### APPEAL SUMMARY

<b>Appeal ID:</b> 16170	<b>Project Address:</b> 621 SW Alder St, Unit #700
<b>Hearing Date:</b> 11/22/17	<b>Appellant Name:</b> Ivana Gazic
<b>Case No.:</b> B-008	<b>Appellant Phone:</b> 503-206-3814
<b>Appeal Type:</b> Building	<b>Plans Examiner/Inspector:</b> Steven Freeh
<b>Project Type:</b> commercial	<b>Stories:</b> 9 <b>Occupancy:</b> B <b>Construction Type:</b> I-A
<b>Building/Business Name:</b>	<b>Fire Sprinklers:</b> Yes - fully sprinklered
<b>Appeal Involves:</b> Alteration of an existing structure <b>LUR or Permit Application No.:</b> 17-254540-CO	
<b>Plan Submitted Option:</b> pdf [File 1] [File 2]	<b>Proposed use:</b> not given

**CKA OFFICE REMODEL**  
**7TH FLOOR - ELECTRIC BUILDING**

BUILDING CODE APPEAL

3  
ELEVATOR LOBBY - OFFICE ENTRANCE  
1/2" = 1'-0"

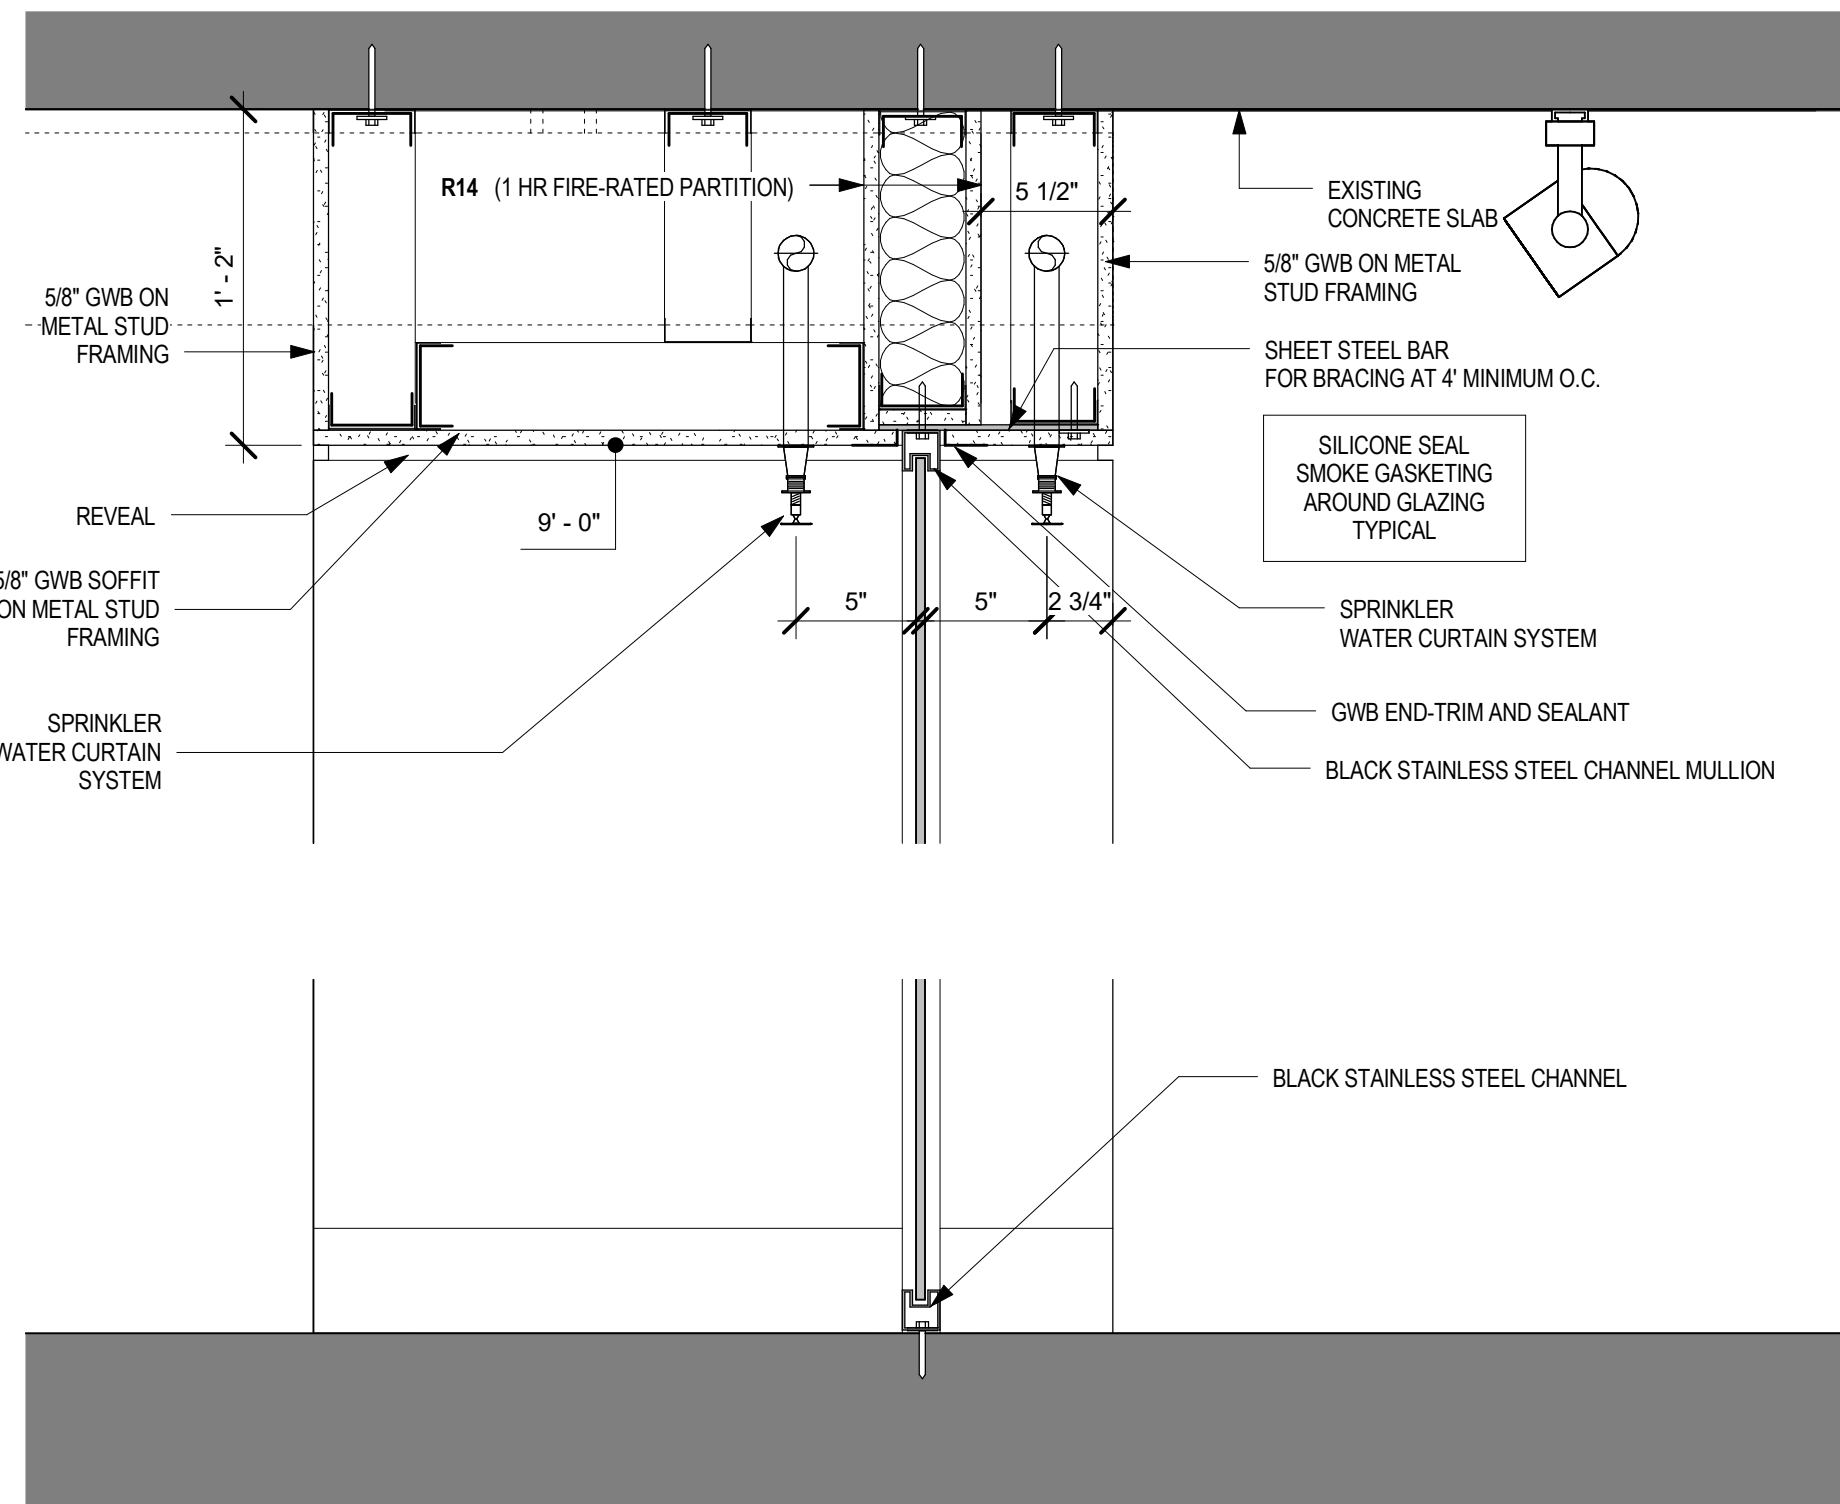
**Proposed Design** The proposed design consists of 1-HR fire rated partition walls (P84) and 1/2" tempered glass at Door # 722 and at the new windows into the office space. In place of the fire rated doors and windows, we propose a deluge sprinkler wall wash system installed to the satisfaction of the Fire Marshal's Office on either side of the glass door (#722) and the new windows (see attached plan A4.01). This "water curtain" system is described in the National Fire Protection Association (NFPA) Standard No. 13, Section 5-3.7 and 4-13.14.1 to protect proposed non-fire rated door construction in an exit-access doorway. In addition, silicone smoke gasketing will be installed on all edges of glass door and at glass panel joints.

Closely spaced, quick response sprinkler heads (@ 6' o.c. minimum) will be located at the ceiling on both sides of the door opening and the glazing and will be designed to wash glazing for maximum effect.

Water curtains are a recommended means of providing exposure protection to buildings. Reference NFPA 13 Section 3-7 and Section 5.6.

**1. Sprinkler curtain in lieu of 1 hour rated openings in elevator lobby: Granted provided sprinklers are installed per the Fire Marshal's office and are capable of wetting the entire surface. A separate permit from the Fire Marshal's Office is required.**
